**DRAFT**  
**EXPLANATION OF SIGNIFICANT DIFFERENCES**  
**CONTINENTAL STEEL SUPERFUND SITE**  
**FINAL RECORD OF DECISION, SEPTEMBER 1998**  
**AS AMENDED SEPTEMBER 2003**

**Indiana Department of Environmental Management**  
**August 2005**

*This fact sheet provides background and information about proposed changes to the Continental Steel Remedial Action including elimination of the Corrective Action Management Unit (CAMU), which was to be an on-site landfill.*

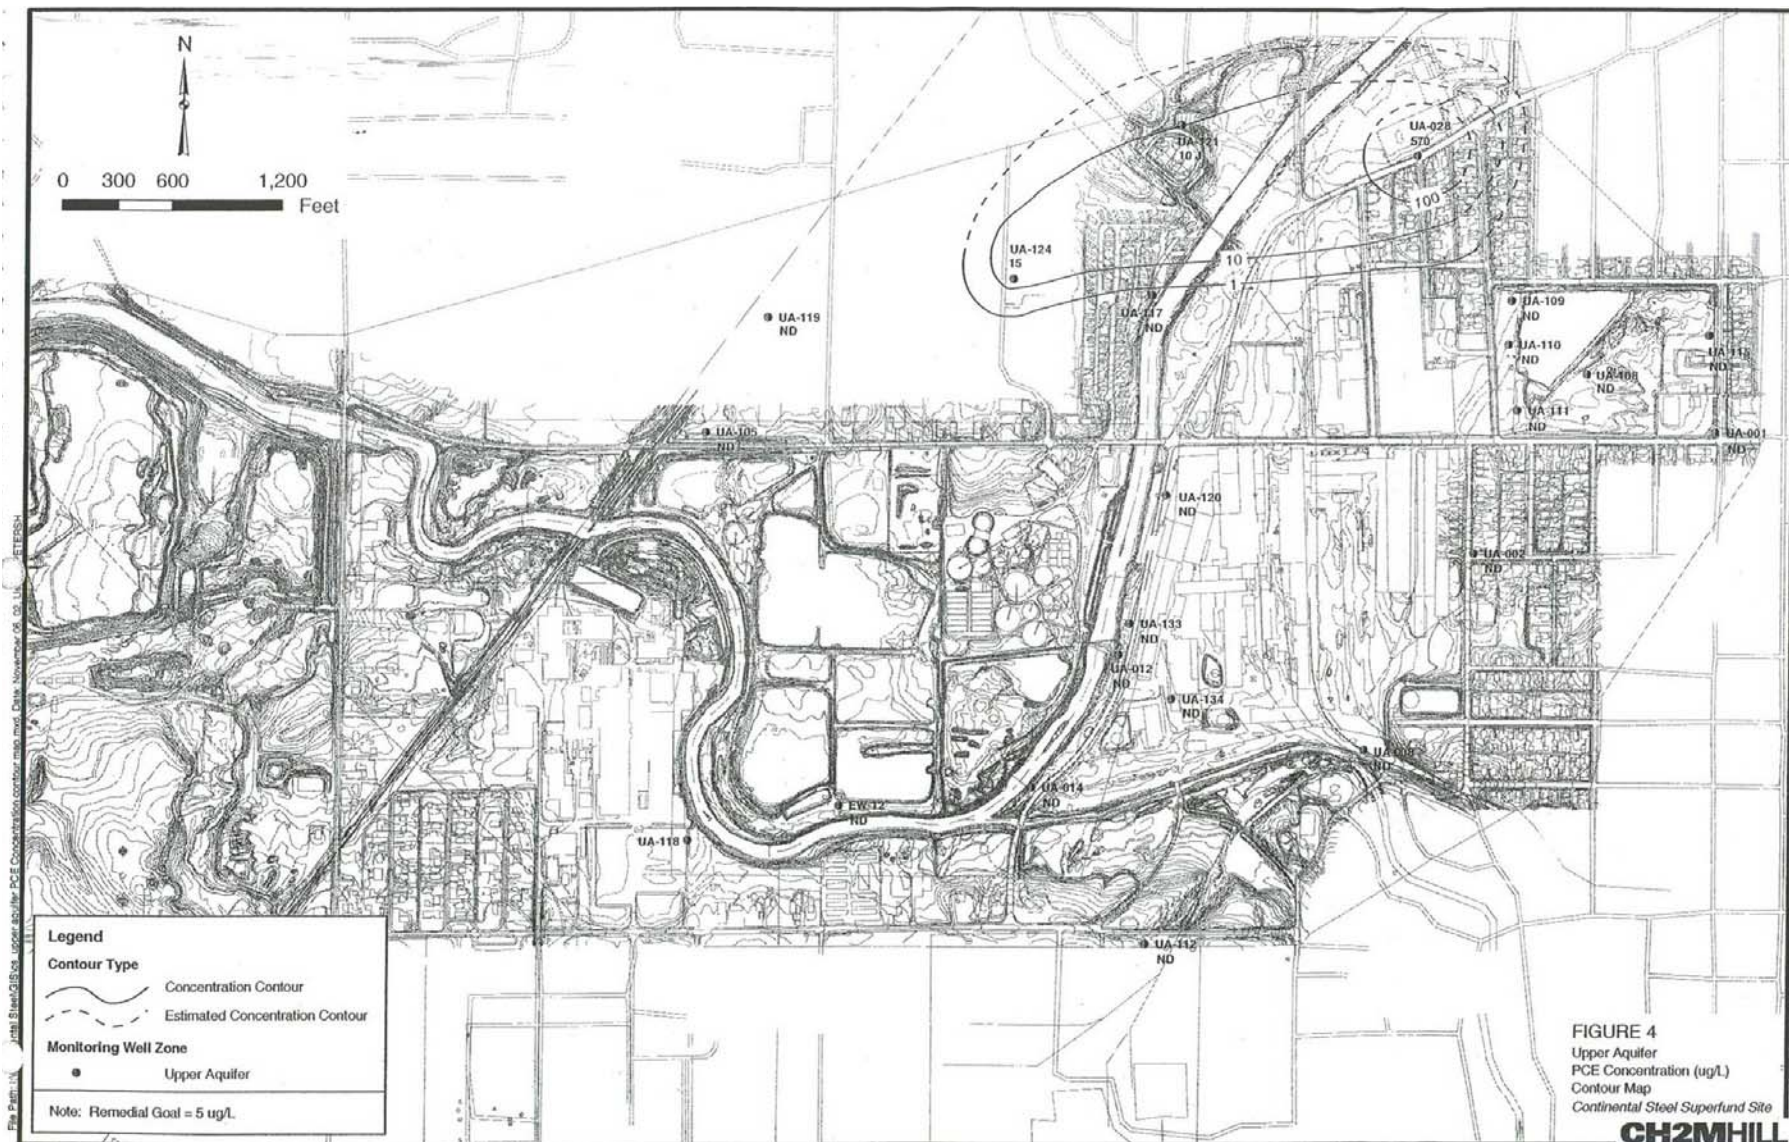
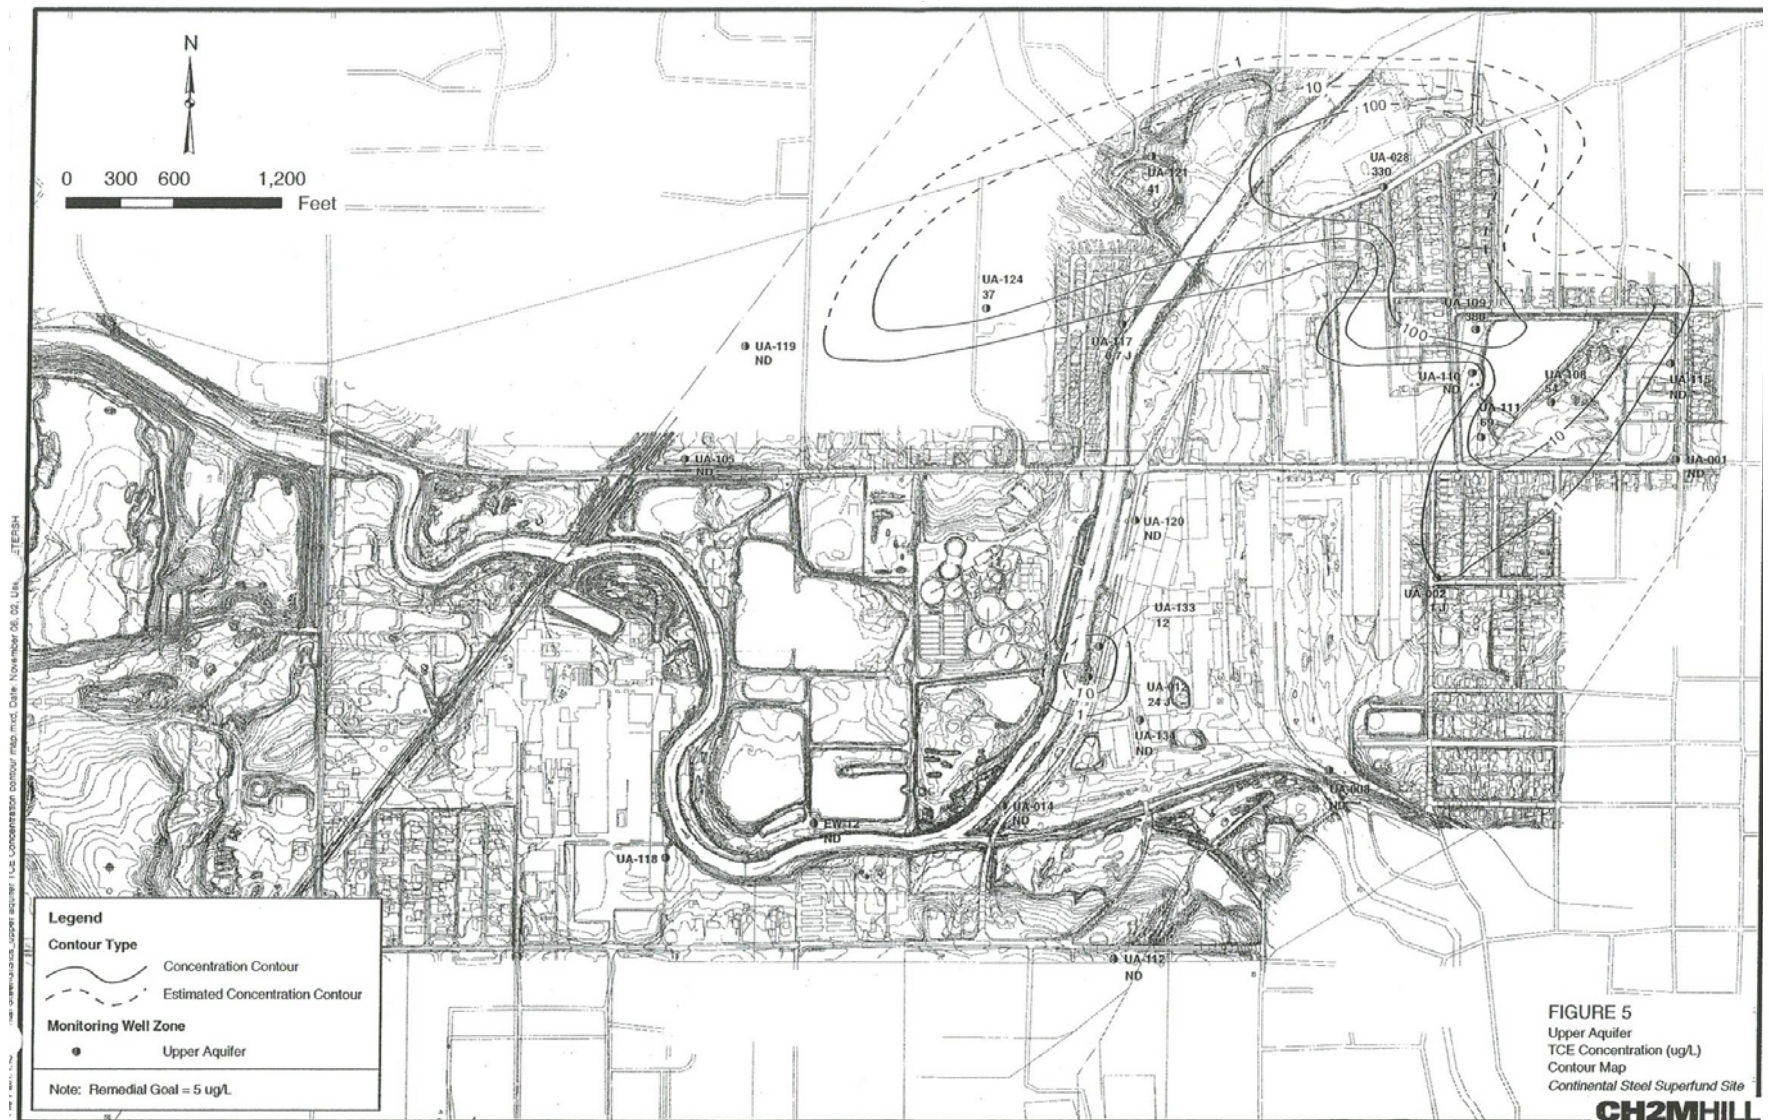
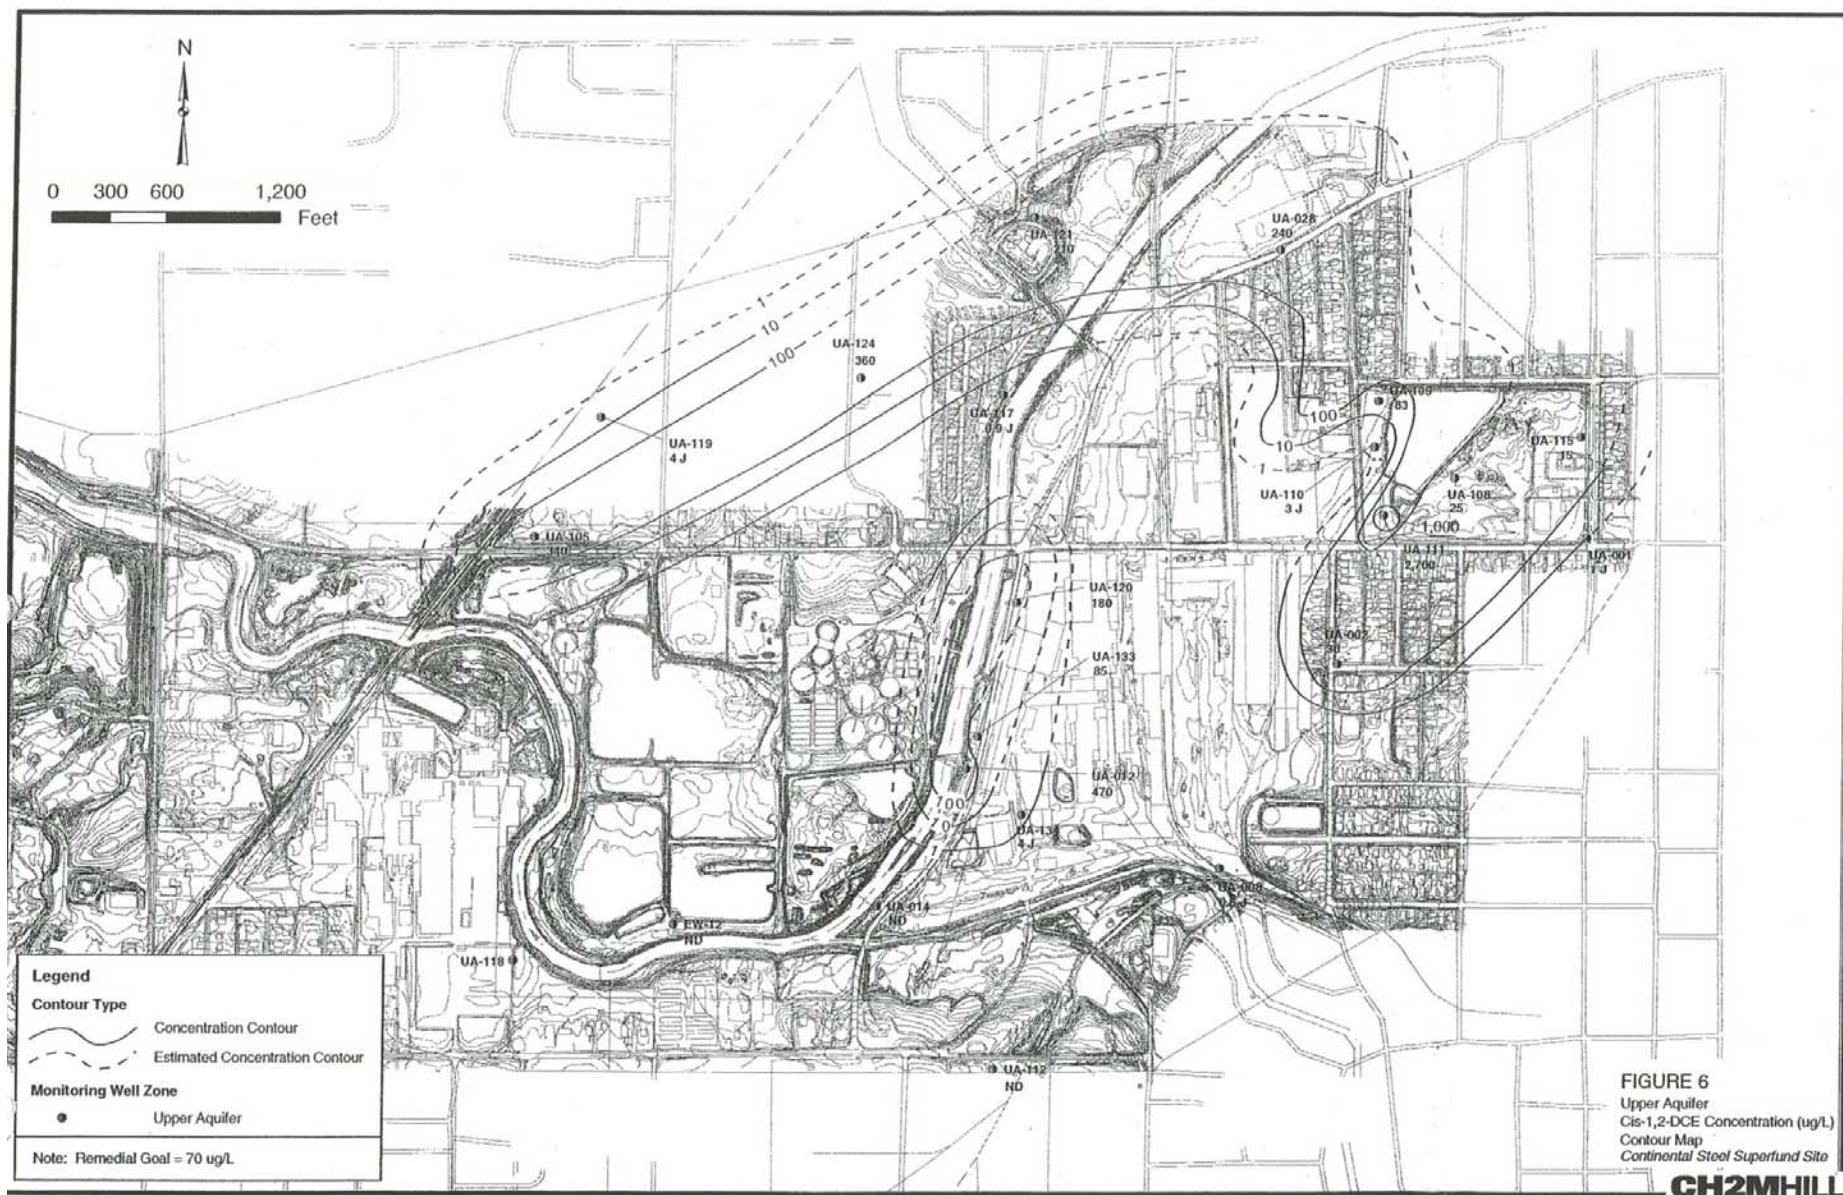
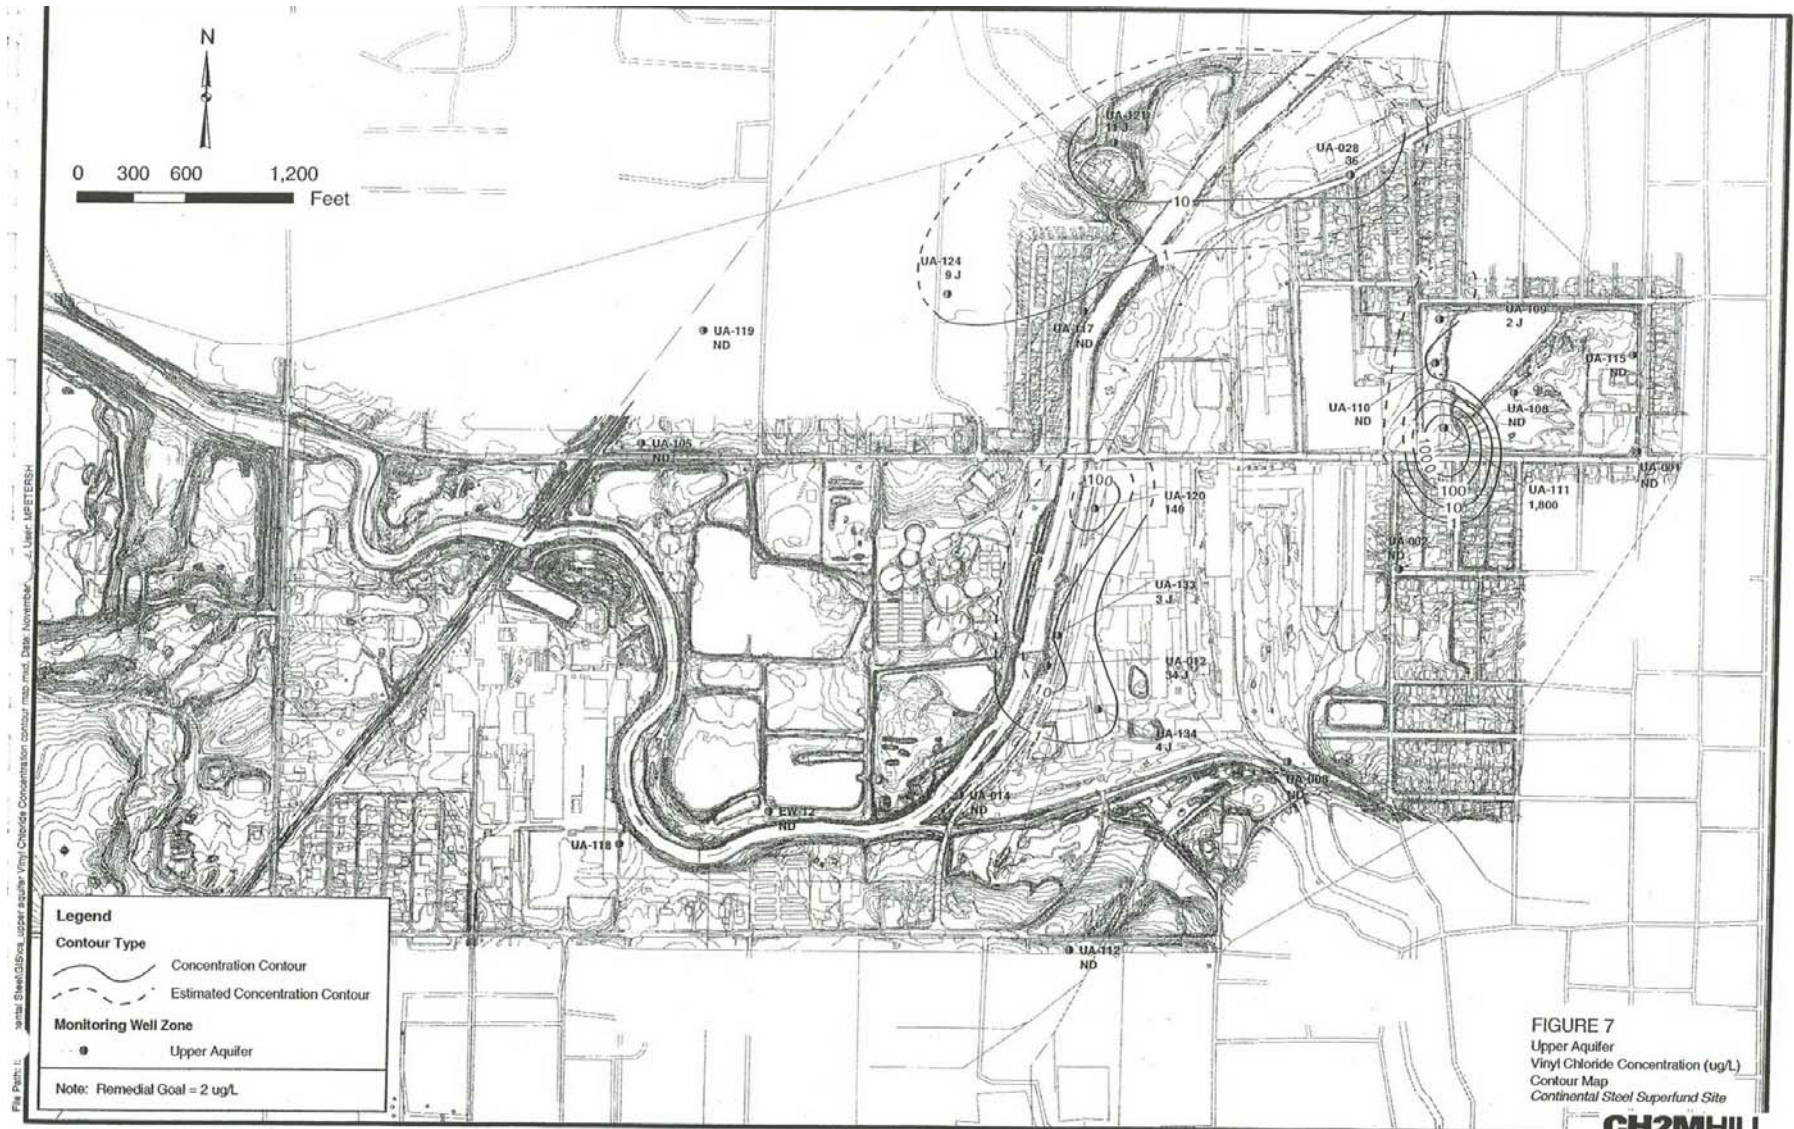
Groundwater data collected during the Remedial Investigation (RI) and the remedial design investigation indicate that this waste does not leach contaminants above Maximum Contaminant Levels (MCLs) into the groundwater. This is probably attributable to the fact that the sludge in the polishing lagoons and drying beds had been processed (mixed with lime) through the on site wastewater treatment plant when the facility was operating. IDEM's interim closure of the primary acid storage lagoons, performed in 1989, addressed the stored acid and untreated sludge. The primary acid storage lagoons had an extremely low pH, and the sludge at the base of these lagoons was untreated. The mixture of the sludge with lime likely reduced the leachability of the metal components and thus the mobility of these contaminants. As a result of the interim closure, the pH of the primary acid lagoon contents was raised and those lagoon beds now contain only treated sludge.

*(See Figures 4-8. These figures were originally published in the Technical Memorandum entitled Continental Steel Superfund Site Contract 5 – Groundwater, Groundwater Flow and Quality Conditions, prepared for **EPA** by **CH2M HILL** on February 7, 2003. The entire memo has been placed in the Administrative Record and is available for viewing at the Public Information Repositories [see Section IX of this ESD for locations]. Under current conditions, prior to **RCRA** closure of the lagoons, the only contaminant detected above **MCLs** in the Lagoon Area upper groundwater during the Remedial Design was Manganese. The **MCL** for Manganese is a secondary standard that may effect the taste or smell of drinking water).*

Surface impoundment closure that meets the requirements of **RCRA** will be performed as planned, however the lagoon contents will not be solidified to provide the base for a **CAMU**. The lagoons will not be consolidated, so the profile of the land will be more amenable to beneficial reuse. A cover will be placed over the entire area, similar to that applied at the Main Plant, Markland Quarry and the Slag Area.
